Watts Bar Nuclear Plant, Unit 2
Facility Operating License No. NPF-96
NRC Docket No. 50-391

Subject: Response to Request for Additional Information to Application to Modify Watts Bar Nuclear Plant Unit 2 Technical Specifications 3.7.8 to Extend the Completion Time for an Inoperable Essential Raw Cooling Water Train on a One-Time Basis (WBN-TS-18-07) (EPID L-2019-LLA-0020)

Response to NRC Request for Additional Information WBN2 Request for One-Time Extension of Completion Time for TS 3.7.8 (L-2019-LLA-0020)

Figure 1 - WBN ERCW Intake Temperature History

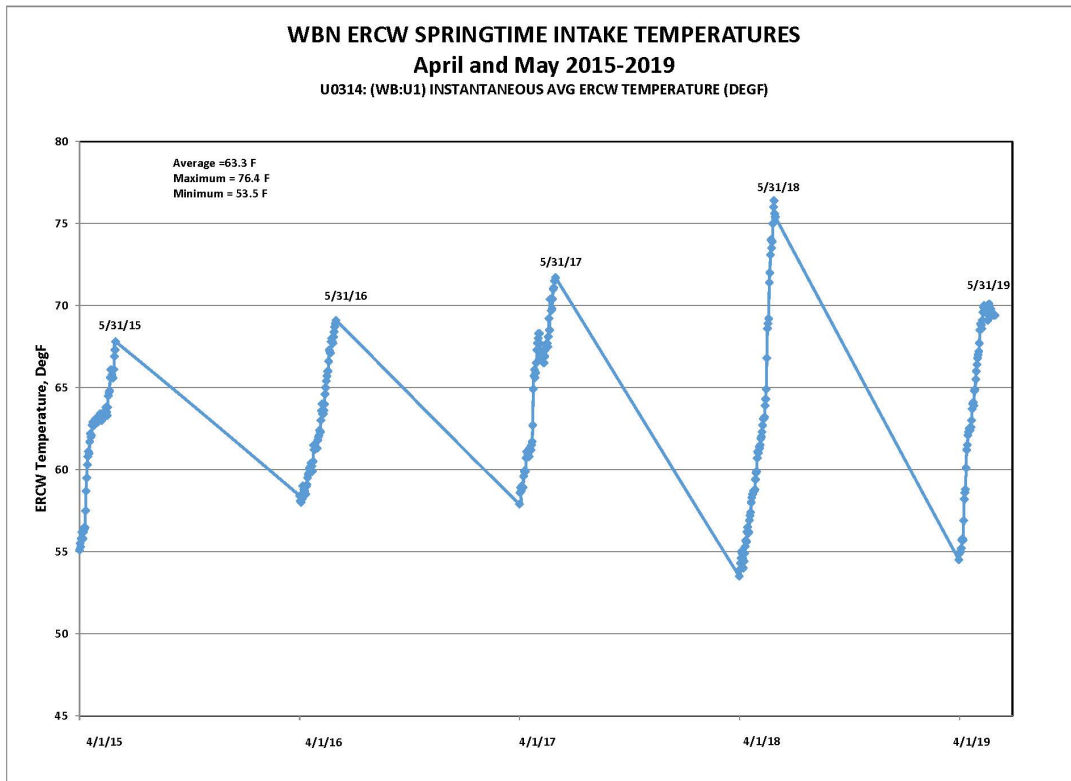
The October 24, 2019, supplement showed ERCW temperatures exceeding 71°F towards the middle to later periods of May in 2017 and 2018. The supplement did not contain ERCW temperature data for May 2019. Given the proposed Note allowing applicability of the proposed CONDITION through May 31, 2020, it appears ERCW temperature going above 71 °F during the maintenance period is credible.

- 1. Please provide ERCW temperature data for May 2019.*
- 2. Please either confirm that the statements in Section 3.2.2 of the February 7, 2019, letter remain valid, or provide a revised statement that accounts for the October 24, 2019, supplement.*
- 3. Please provide an evaluation that demonstrates the acceptability of continued operation for up to 10 days with one ERCW train inoperable. Alternatively, provide proposed TSs that will not allow continued plant operation in the proposed CONDITION A after 7 days or after one of the NOTES above the CONDITION A restricting the entry into the CONDITION are not met.*

1. Figure 1 provides the ERCW temperature for May 2019.
2. TVA confirms that the statements in Section 3.2.2 of TVA Letter to NRC, CNL-19-014, "Application to Modify Watts Bar Nuclear Plant Unit 2 Technical Specifications 3.7.8 to Extend the Completion Time for an Inoperable Essential Raw Cooling Water Train on a One-Time Basis (WBN-TS-18-07)," dated February 7, 2019 (ML19038A483), remain valid.
